# Society of American Florists

DSUP#2003-0032

Docket Item #7  
DEVELOPMENT SPECIAL USE PERMIT #2003-0032  
SOCIETY OF AMERICAN FLORISTS

Planning Commission Meeting  
February 1, 2005

ATTACHMENT #1  
TDSUP # 2003-0032

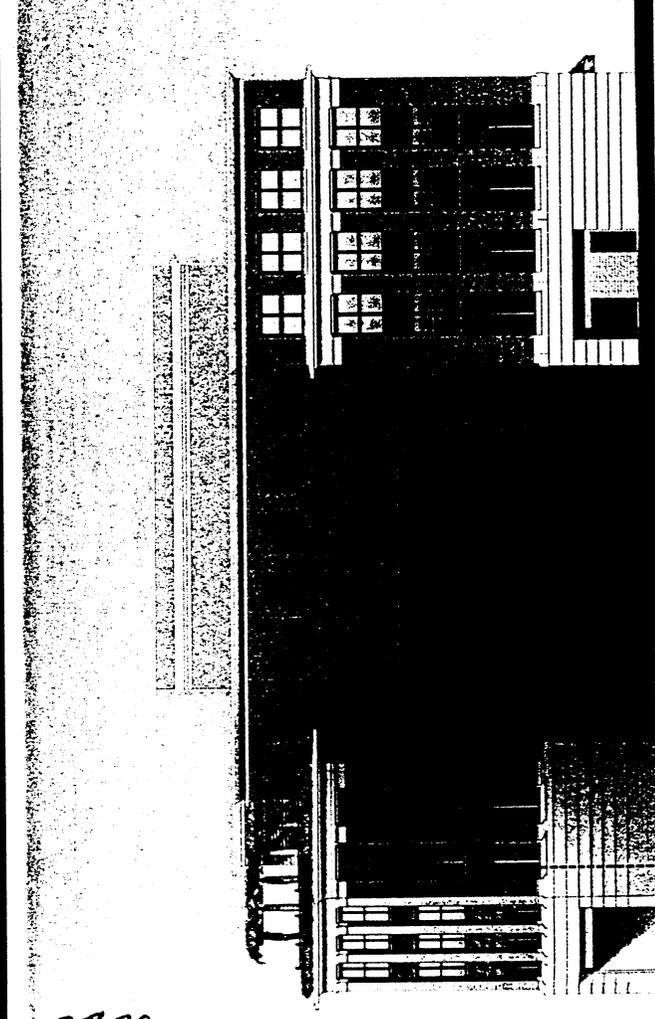
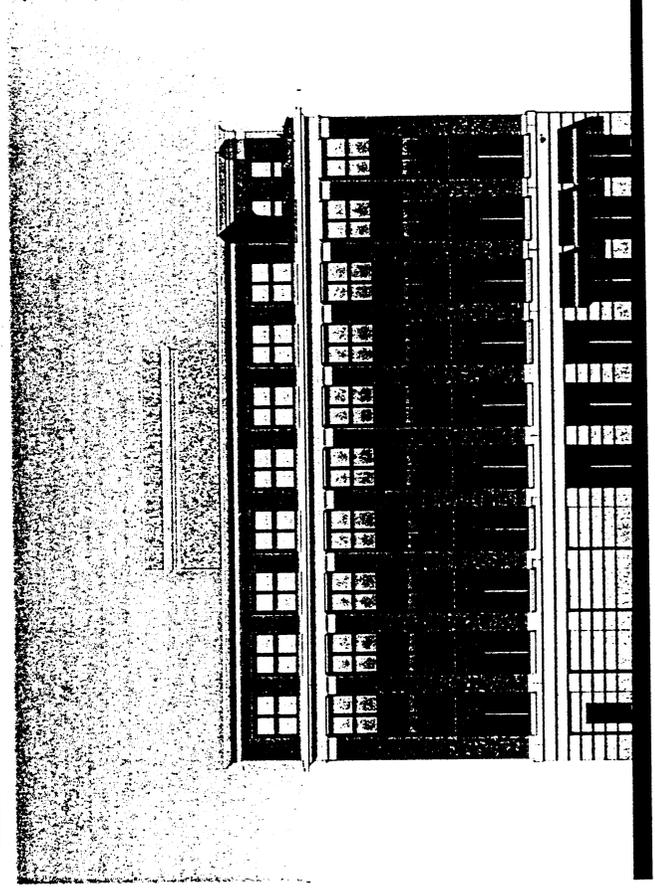
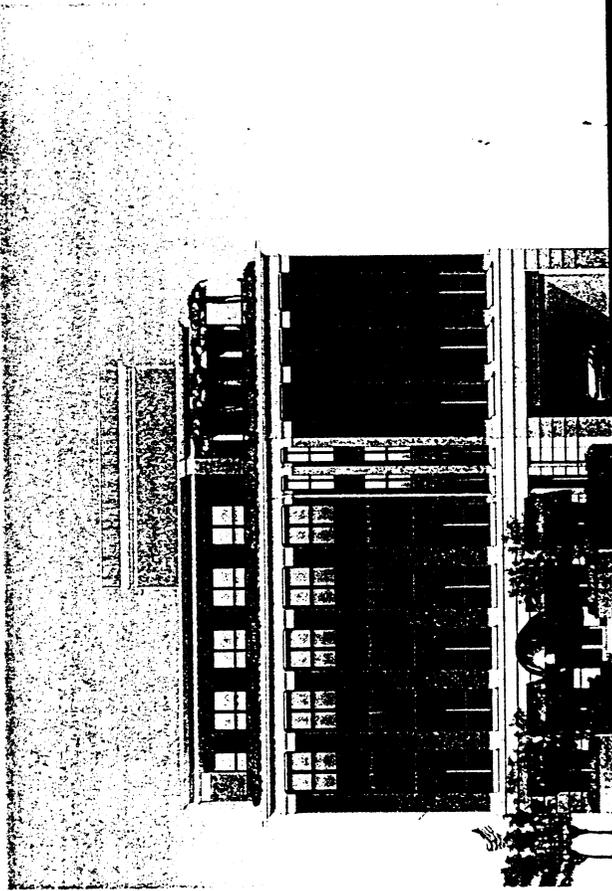
9. **CONDITION AMENDED BY PLANNING COMMISSION:** The open space courtyard-plaza at the corner shall be revised as generally depicted in *Attachment #1* to decrease the amount of hardscape and increase the amount of landscaping to the satisfaction of the Director of P&Z. The courtyard-plaza shall also provide the level of detail and amenities depicted on the preliminary plan, and shall also provide the following:
